## D4CB-D vs D4CB-E Cylinder Head Difference

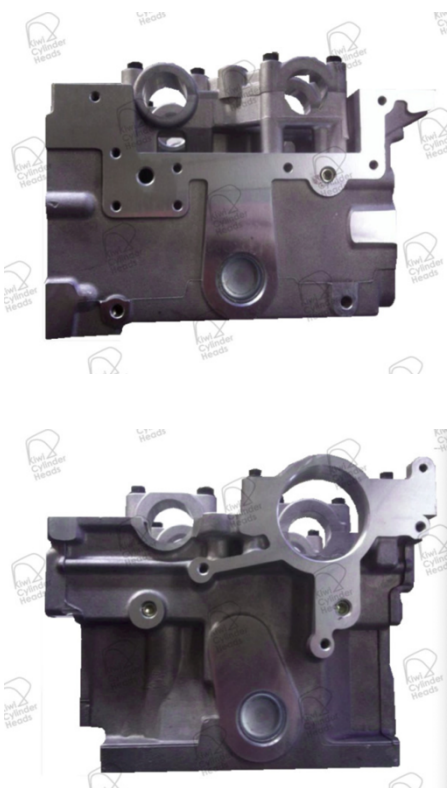
### D4CB-D

1 Frost Plug in each end

Injector Ports = 17.54mm Diameter

### D4CB-E

2 Frost Plugs in each end

Injector Ports = 20.24mm Diameter
